Packet Guide
City of Charlottesville
Board of Architectural Review
Regular Meeting
April 15, 2025 5:30 p.m.
Hybrid Meeting (In-person at Council Chamber and virtual via Zoom)

**BAR MINUTES
CITY OF CHARLOTTESVILLE
BOARD OF ARCHITECTURAL REVIEW**

**City of Charlottesville
Board of Architectural Review
Staff Report
April 15, 2025**

HST25-0072

PHOTO SHOWING THREE OF THE ADDED WINDOWS (PHOTO 20) AND THE ORIGINAL PORTICO

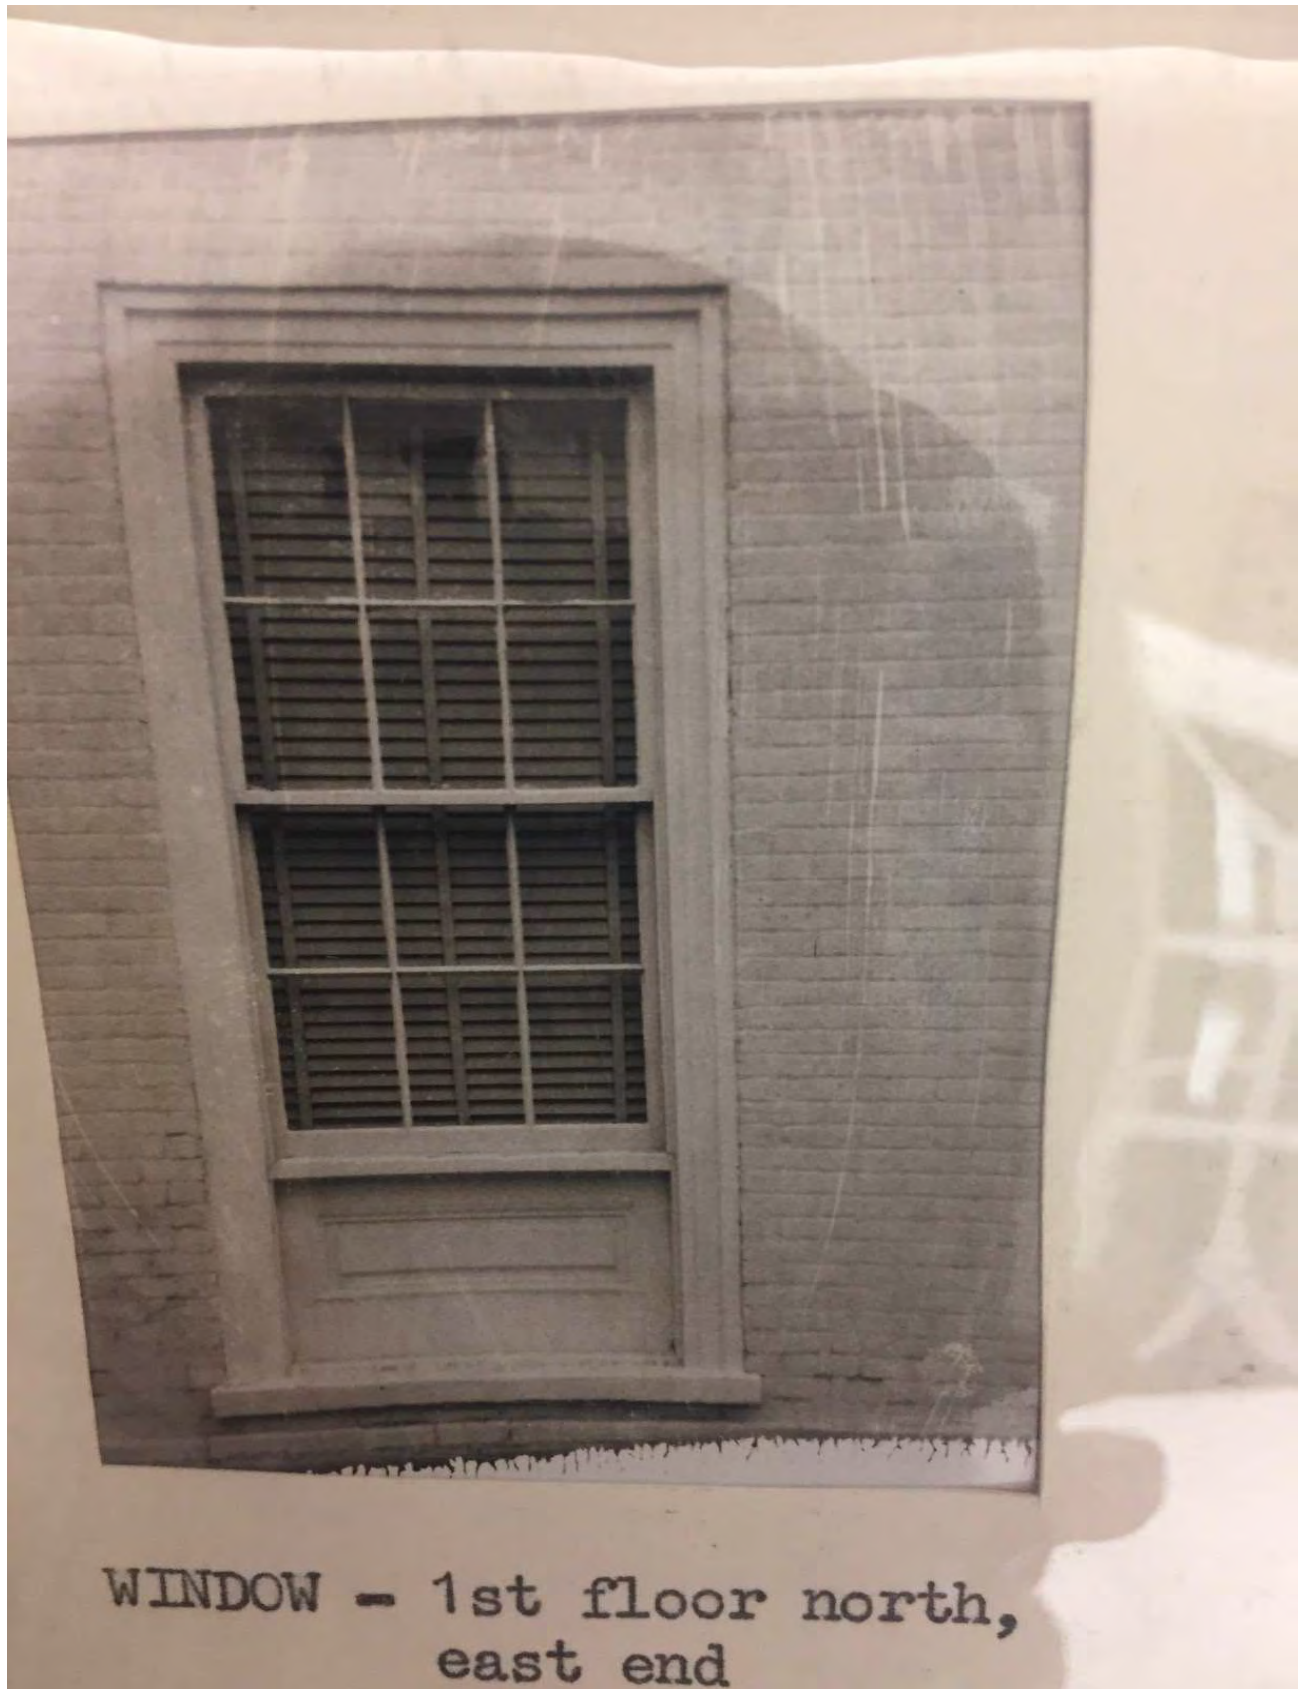
- Install two-story columned portico to match the original one-story portico.
- Portico will surround existing fire escape and continue to serve as an emergency egress. (See photo 10).
- Portico railing to have zig-zag wood railing similar to "The Second Yard" on Market Street (photo 18)
- Install brick handicap ramp that extends from the corner of building to the portico.
- Remove door and steps to right of entry door (photo 19) and replace with historic window that matches the original window (photo 20 of original window)

PHOTO 22 – NON FUNCTIONING DOUBLE DOORS TO BE REPLACED WITH 15 LIGHT DOOR TO MATCH WINDOWS

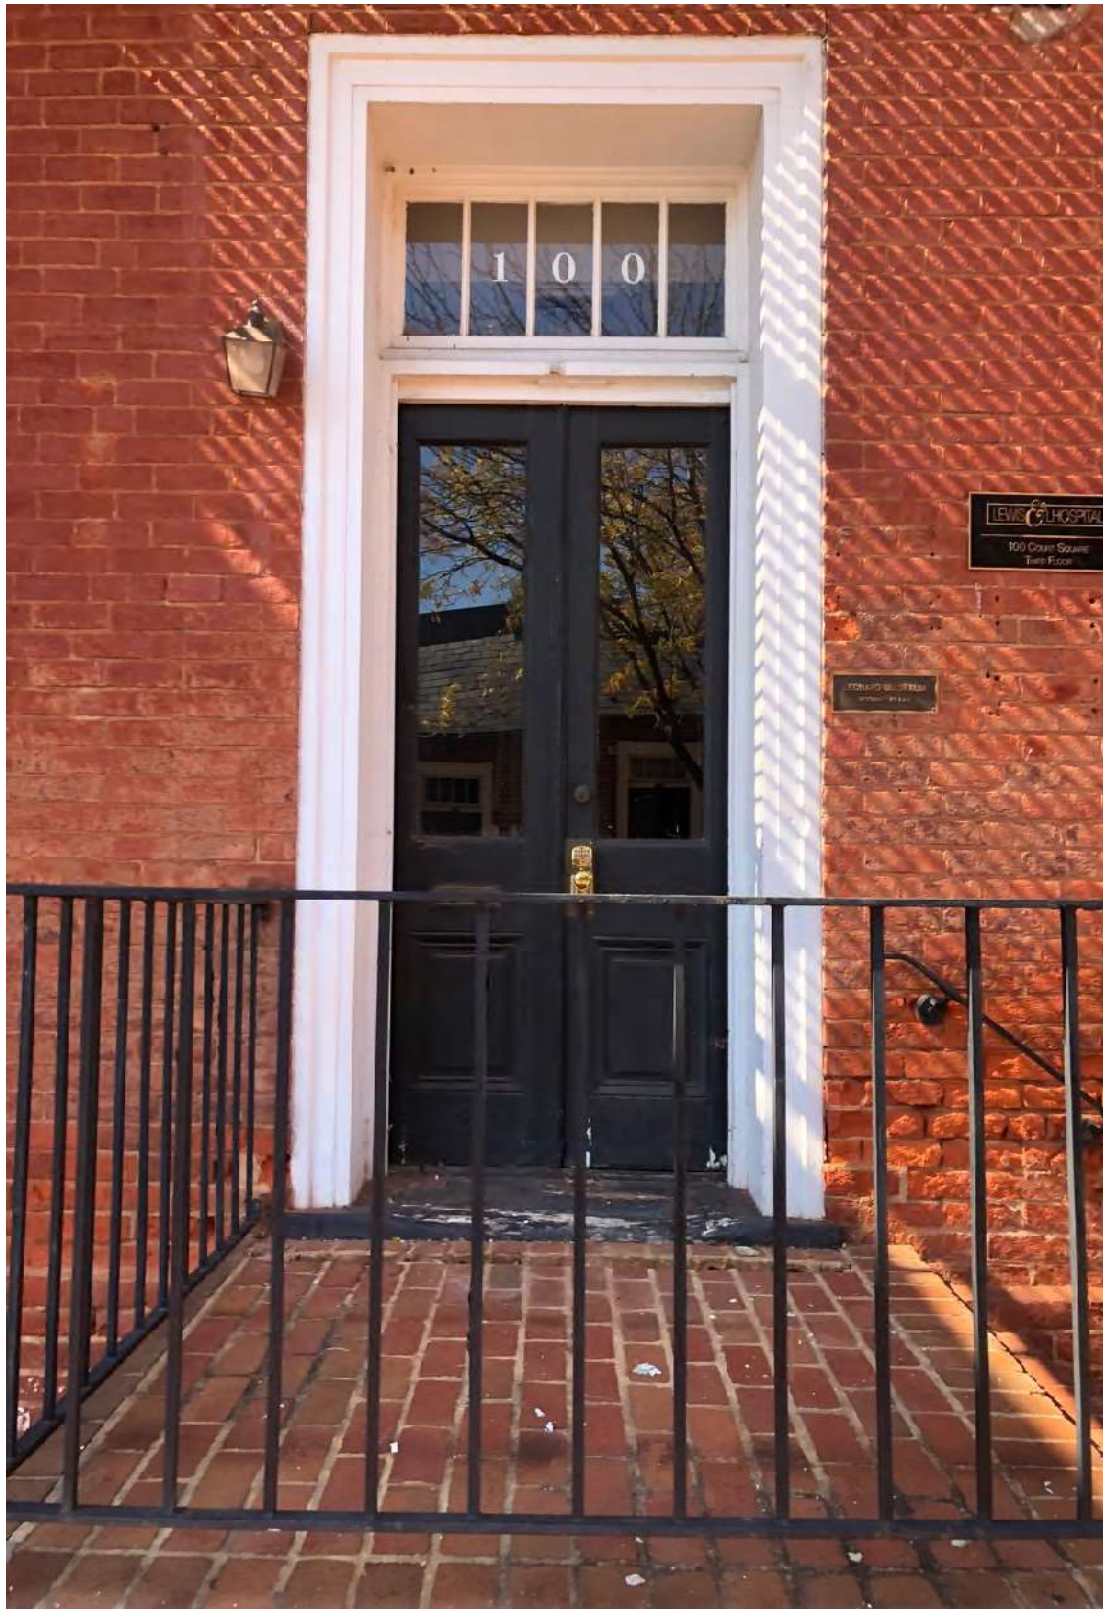
- Install new single 15 light wood entry door with true divide lights to replace non-functioning double doors. (photo 22)
- Eagle Tavern sign to hang by this entrance
- Replace solid wood doors and sidelights (originally widows) with a single true divided light door to look like windows. These doors will provide emergency egress
- Install a handmade copper lantern on each level of portico. (photo 16)
- A large portion of the brick wall will have to be replaced for structural reasons. (photos 3-10)
- Install wood double doors with 15 true divided light doors to gift store. (photo 23 & 24)
- All doors painted to be painted “green-blue” No BS 16D45 – Fine Paints of Europe
- Gas lantern to be installed at gift store entry and at 100 Court Square entry (photo 15)

PHOTO 26 – DECK WITH ARBOR AND TRELLIS TO BE BUILT TO OBSURE SATELLITE DISHES AND AC CHILLER

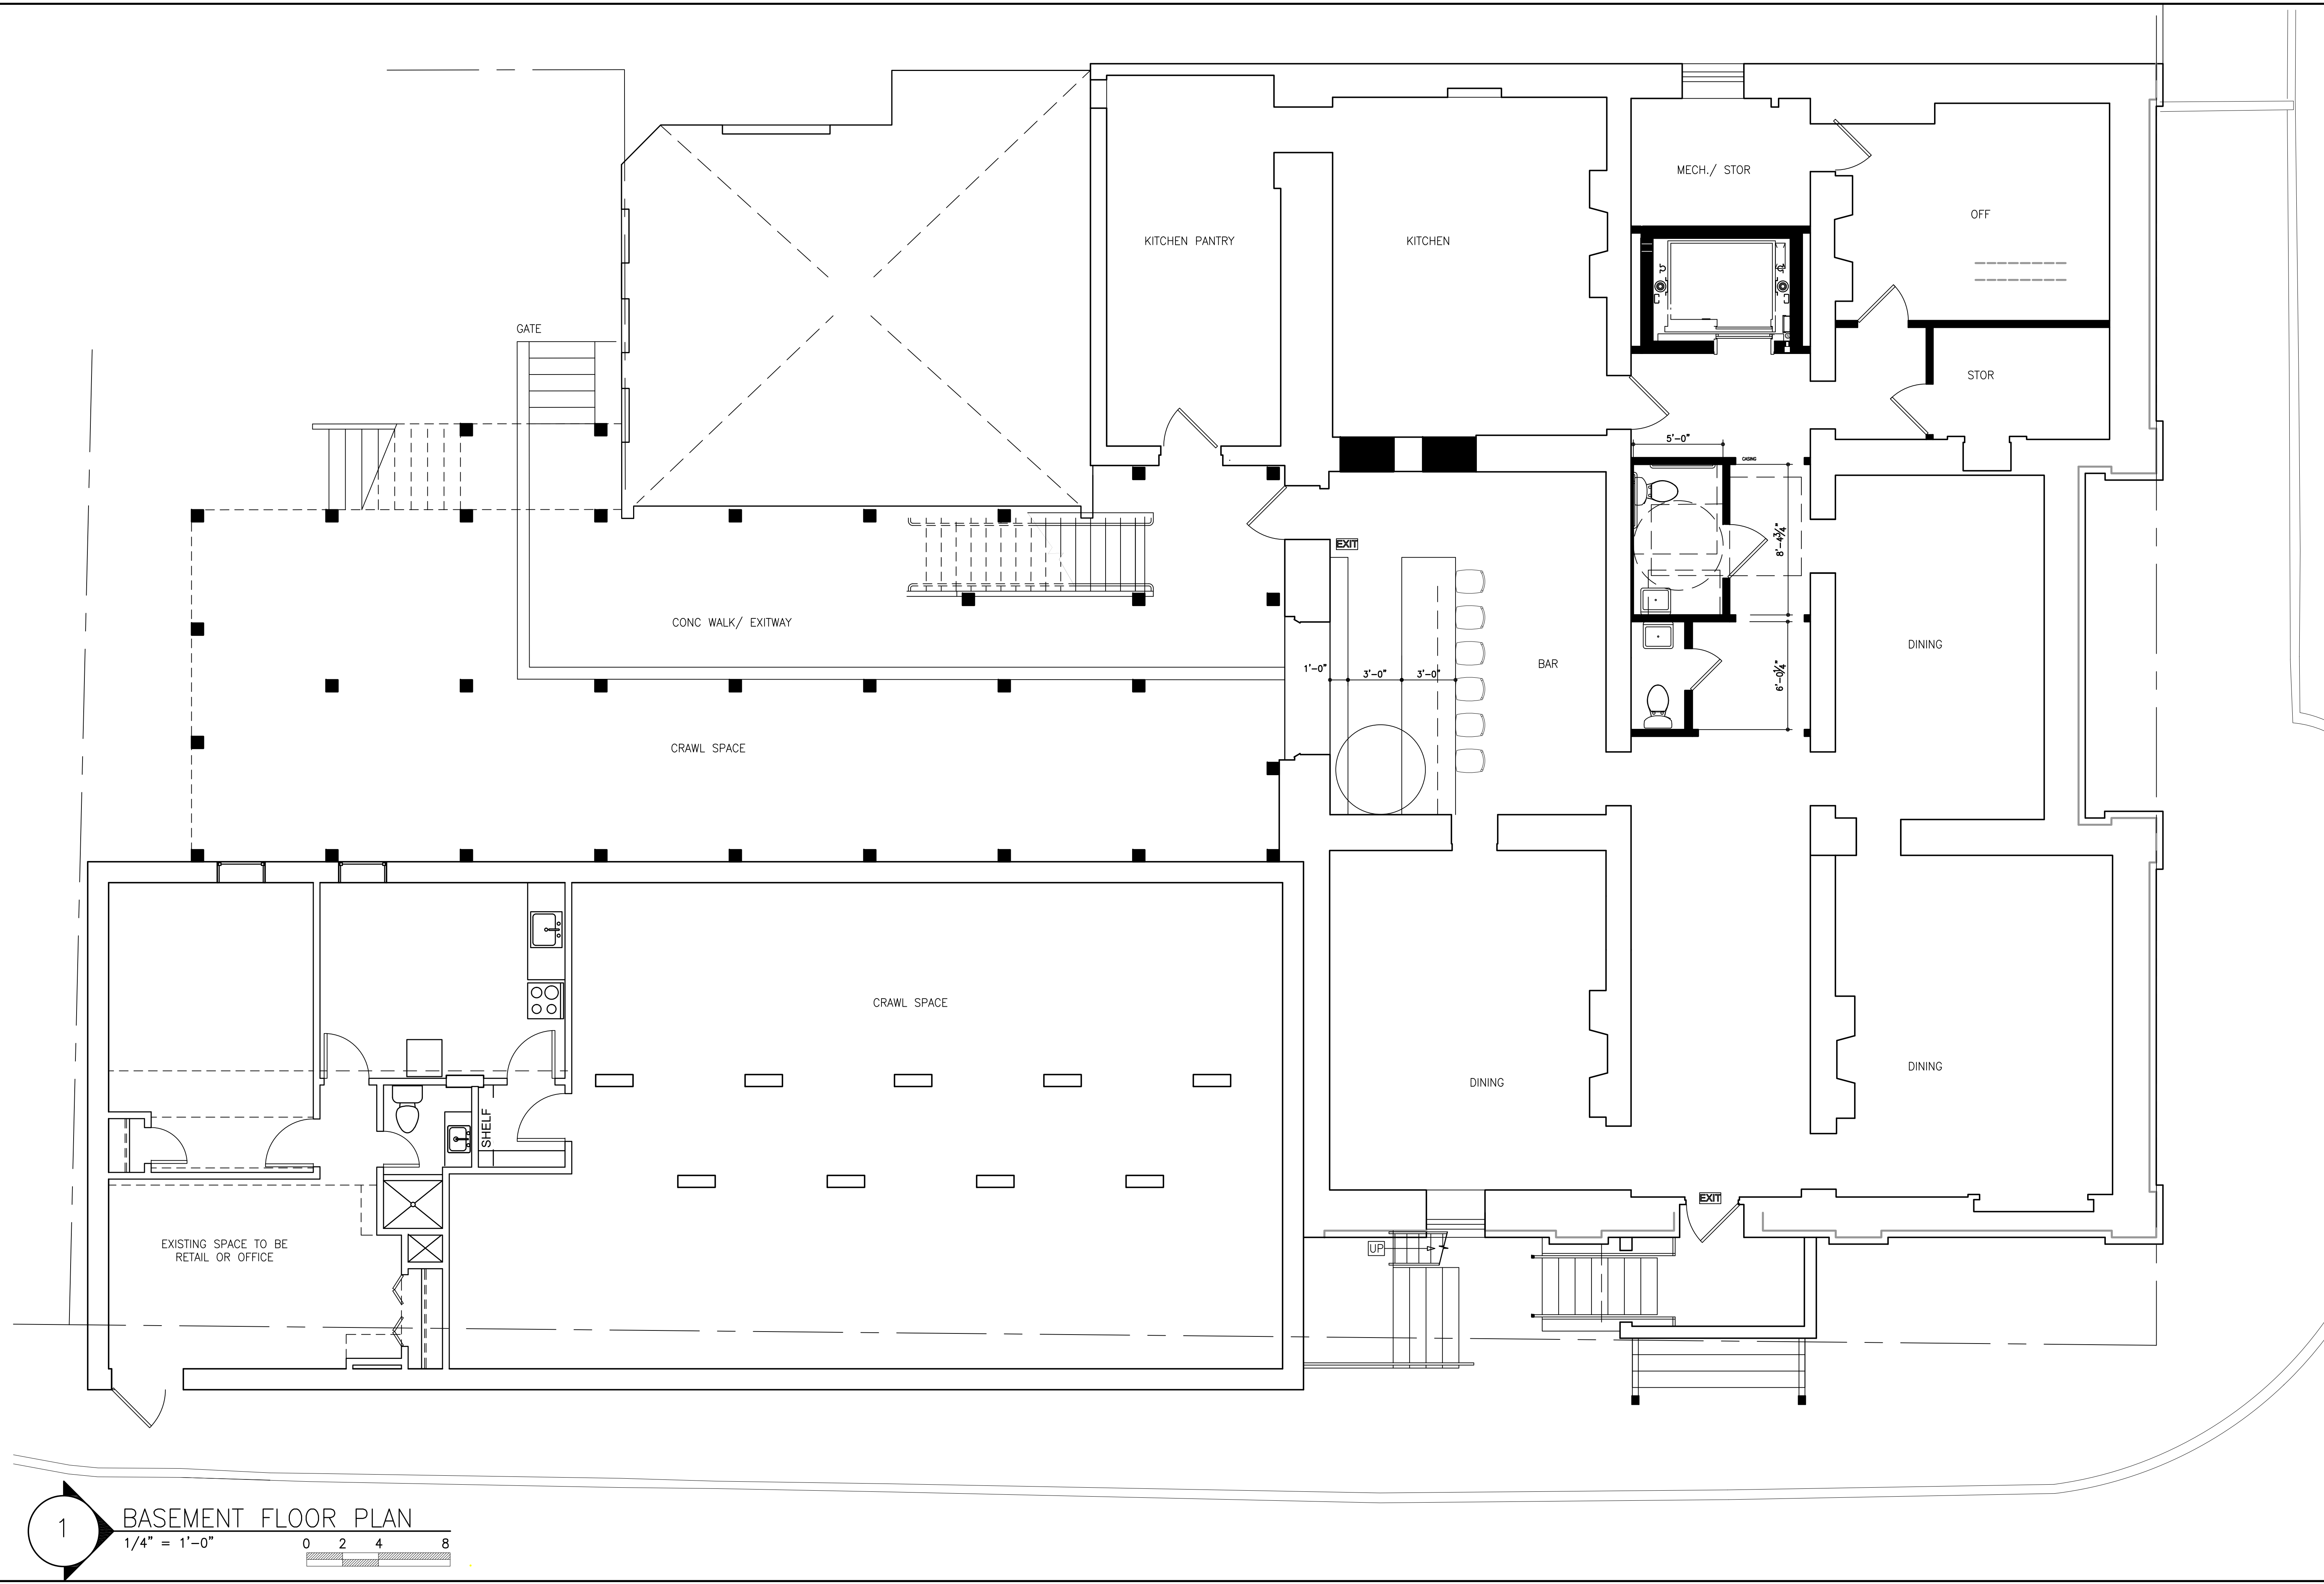
- Replace mismatched, un-original windows with matching windows
- A glass and wood door to match the windows will be installed in the center for emergency egress and to access the deck. (photo 24 & 25)
